## **CRICHTON COMMERCE PLACE SUBDIVISION,** **RESUBDIVISION OF LOTS 1 & 2**

APPLICATION NUMBER 8 DATE October 1, 2015  
APPLICANT Crichton Commerce Place Subdivision Resubdivision of Lots 1 & 2  
REQUEST Subdivision

# DETAIL SITE PLAN

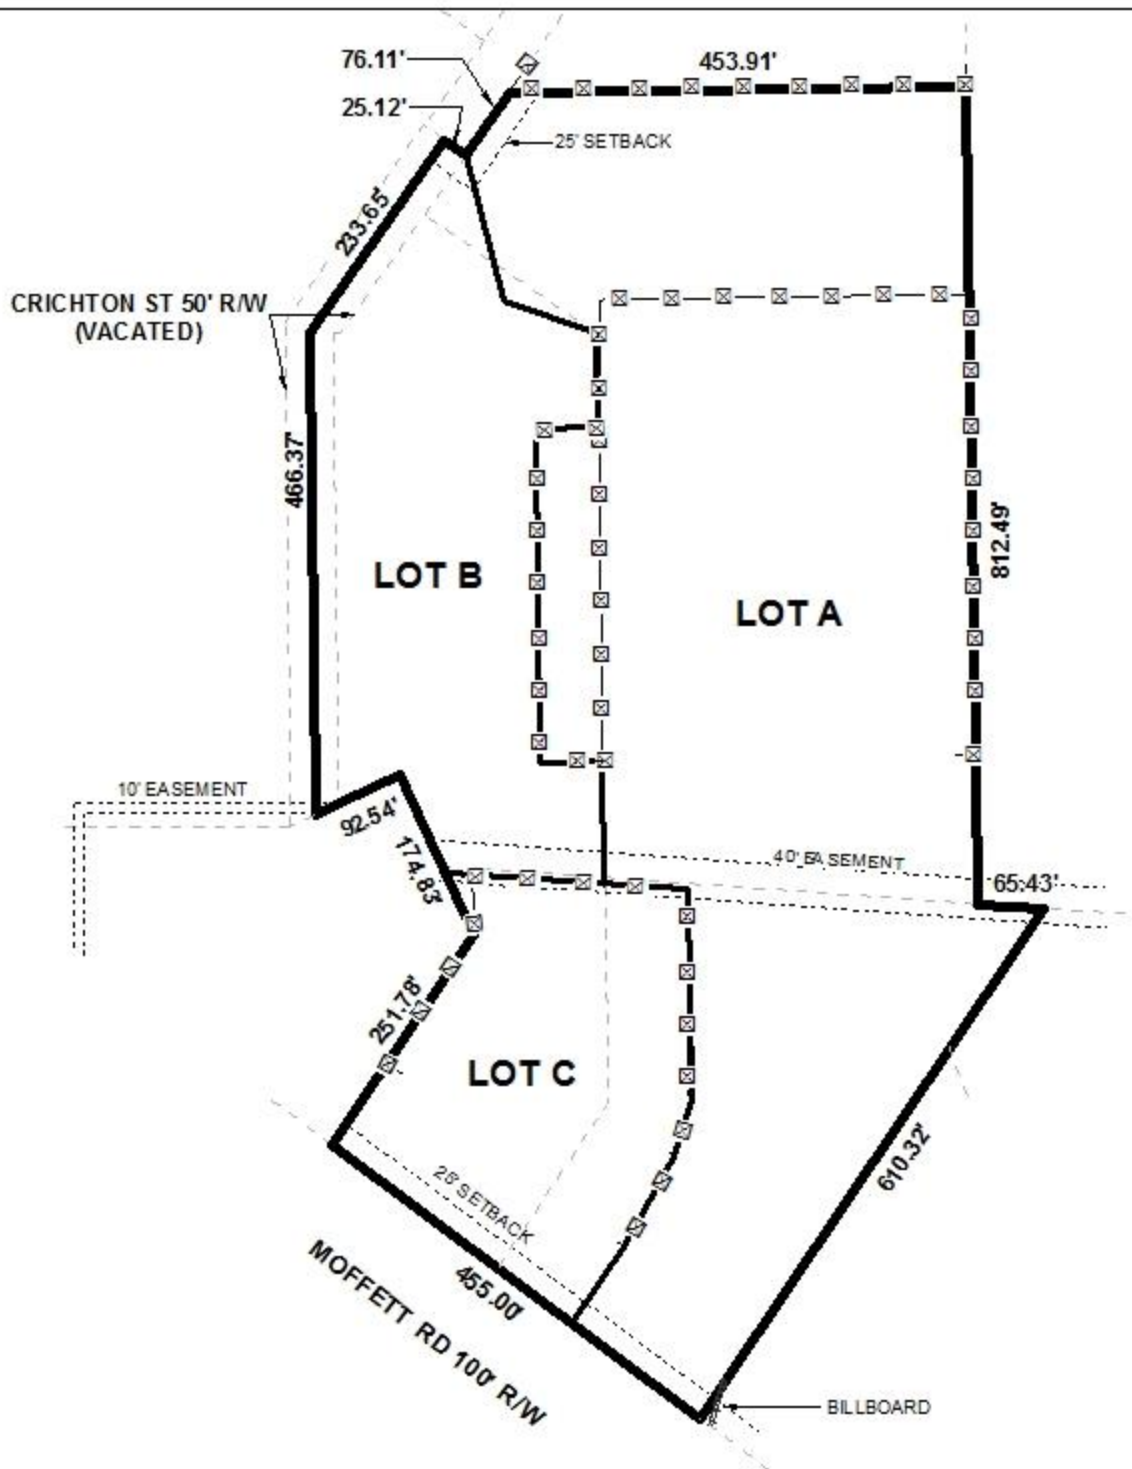
It should be noted that the proposed Lot B only has 25'± of frontage along Crichton Street. Section V.D.2. of the Subdivision Regulations require all lots to be a minimum of 60' wide at the minimum building setback. The 25-foot minimum building setback line, required in Section V.D.9., is shown on the preliminary plat along both frontages for all lots, including Lot B. The setback should be revised to be located where the proposed Lot B is at least 60' wide on the Final Plat, if approved.

The preliminary plat illustrates existing easements. These should remain on the Final Plat, if approved, along with a note stating that no structures are to be erected in any easement.

The proposed lot sizes are provided in square feet and acres, and would exceed the minimum required lot size in Section V.D.2. of the Subdivision Regulations. This information should be retained on the Final Plat, if approved.

Per Traffic Engineering, if approved, a note should be placed on the Final Plat, stating that each lot is limited to one curb cut per frontage, with the size, location and design to be approved by ALDOT (where applicable) and Traffic Engineering and conform to AASHTO standards. It should be noted that there is an existing, unapproved driveway accessing Crichton Street which appears to cross the property line between the proposed Lots A and B. A condition of approval for the Administrative Planned Unit Development was "For 3232 Moffett Road, removal of the unpermitted, unpaved driveway to Crichton Street, or submission of appropriate land disturbance permits to create the driveway and pave with asphalt or concrete, along with adequate documentation that Crichton Street meets City standards where the driveway connects." If approved, the applicant should either obtain the necessary permits for the driveway to Crichton Street or submit photographic evidence that the driveway has been removed prior to the signing of the Final Plat.

- 1) revision of the 25' minimum building setback line where all lots are a minimum of 60' wide;
- 2) approval from the Board of Zoning Adjustment for changes to the site plan for the previously approved surfacing variance for Lot C;

- 3) approval of a Planned Unit Development by the Planning Commission if shared access and parking is proposed between lots;
- 4) either obtain all necessary permit for the existing driveway to Crichton Street or provide photographic evidence that the driveway has been removed prior to the signing of the Final Plat;

- 5) placement of a note on the Final Plat stating that each lot is limited to one curb cut per frontage with any changes to the size, design or location of the curb-cuts to be coordinated with ALDOT (where applicable) and Traffic Engineering and conform to AASHTO standards;

- 6) retention of the lot sizes in square feet and acres, or placement of a table on the plat with the same information, revised to reflect dedication;
